# Humboldt Regional Climate Action Plan and CEQA GHG Emissions Thresholds

## **Final Environmental Impact Report**

State Clearinghouse #2024081319

**October 3, 2025**

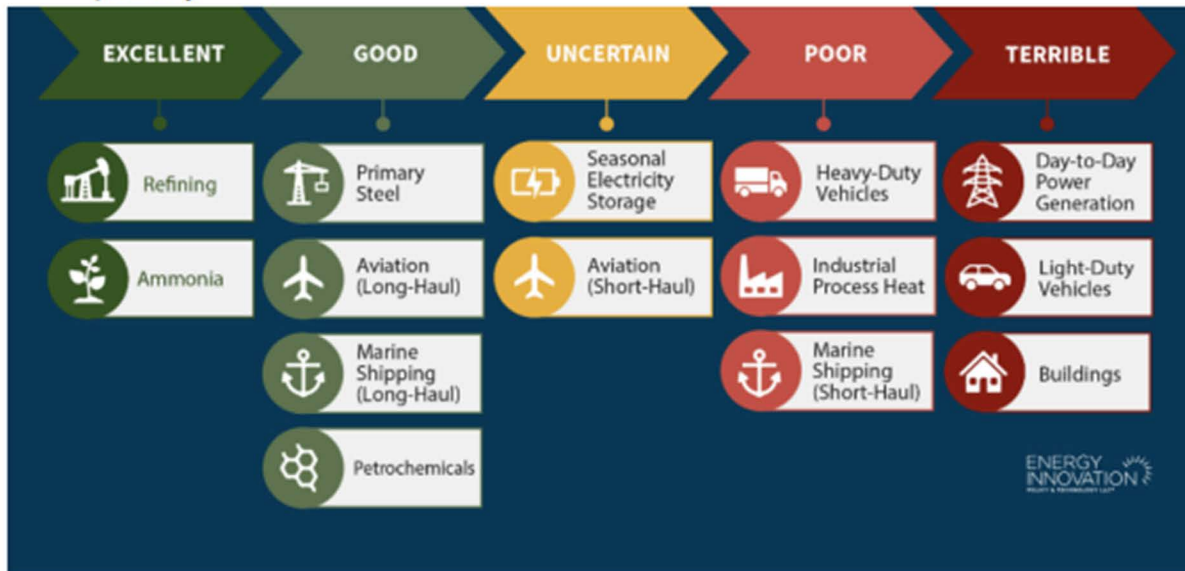
- The current draft of LCFS regulations adds a cap to renewable diesel, and, because it indirectly causes deforestation, it is not considered a climate mitigation in Europe. Our CAP cannot be based on an industry that is contributing to loss of forest sequestration.<sup>55</sup>

102-52

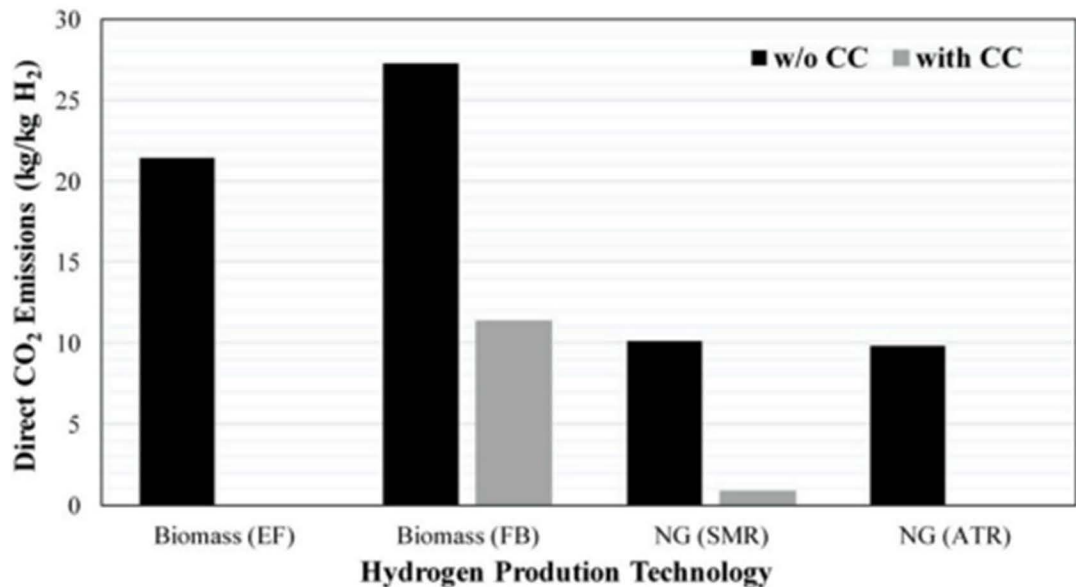
102-52  
cont.

- However, there is virtually no green hydrogen available at this point. The Inflation Reduction Act contains large incentives for green hydrogen and it is hoped that by 2030 that industry can take off.<sup>58</sup>
- The CAP should not endorse the use of any hydrogen for light vehicles, including fueling stations for light vehicles. HTA will be bringing fueling stations for buses and presumably some trucks and perhaps port equipment. 350 Humboldt supported the HTA grant on the assurance that the hydrogen would be green by 2028.
